RE: Response to the following linked planning applications (each, an **Application**):

1. **18/0547/FUL (Main site – detailed and outline)**

2. **18/0548/FUL (Secondary school)**

3. **18/0549/FUL (Chalker's Corner works)**

Developer's analysis of building heights relative to APB

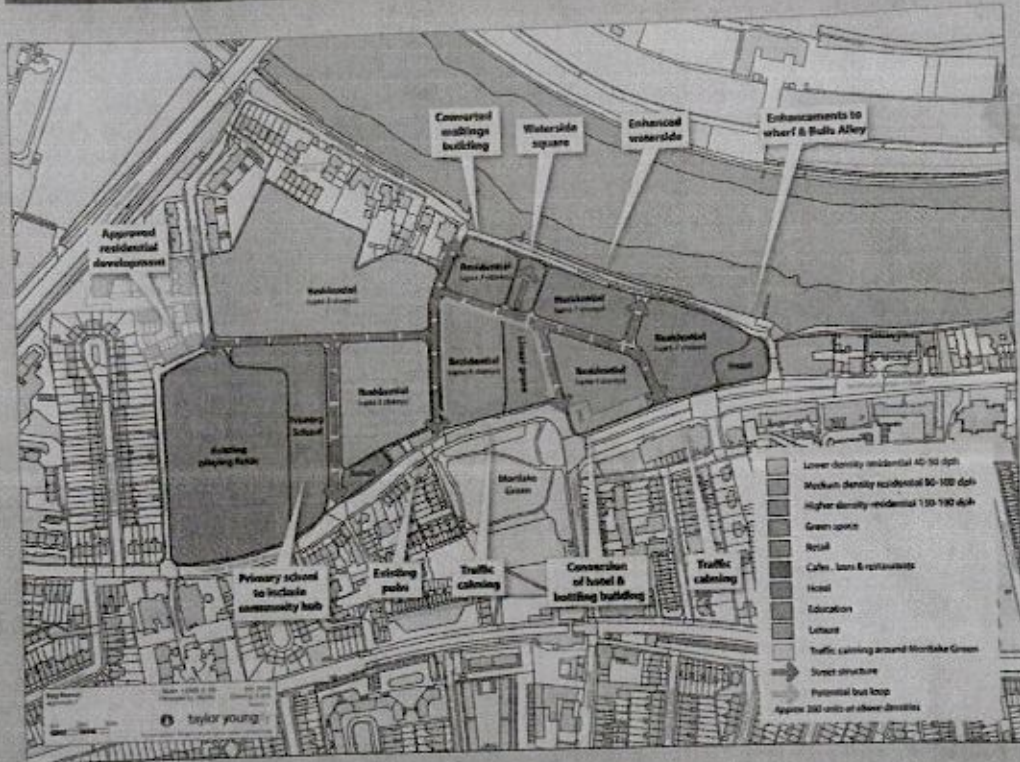
(i) the WL Residential Blocks must not be four-storey high blocks of flats: they should:

- (j) as a function of (i) increasing scale of the WL Residential Blocks to between 4 and 6 levels and (ii) the WL Residential Blocks encroaching on the 2011 Development, instead of being set back from Williams Lane by approximately 2.5 metres as the existing buildings are at present, the Plans pose material issues of:

- (f) heights of buildings diminishing towards the perimeter of the Site in line with the APB (albeit not sufficient to be compliant as regards the WL Residential Blocks);
